Car Stereo Service Bulletin

Model: GEN-CAR No. 346

Subject: Preventing Recurring Damage To Tuner Pack. **Date:** December 27, 1994

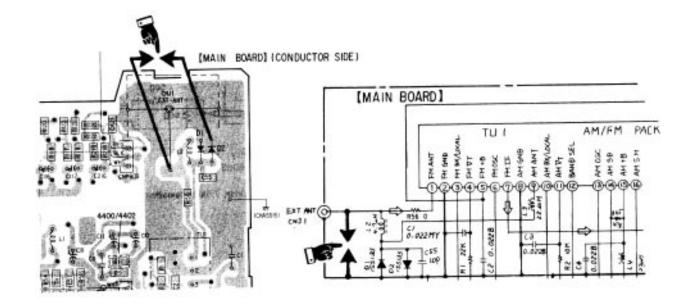
Solution: Replace the tuner pack. Prevent recurring damage to the tuner pack by adding a

discharge gap across the antenna input lead and ground.

REF	DESCRIPTION	PART NUMBER
-	DISCHARGE GAP	1-519-504-11

Example shown is for XR-4400; other models are similar.
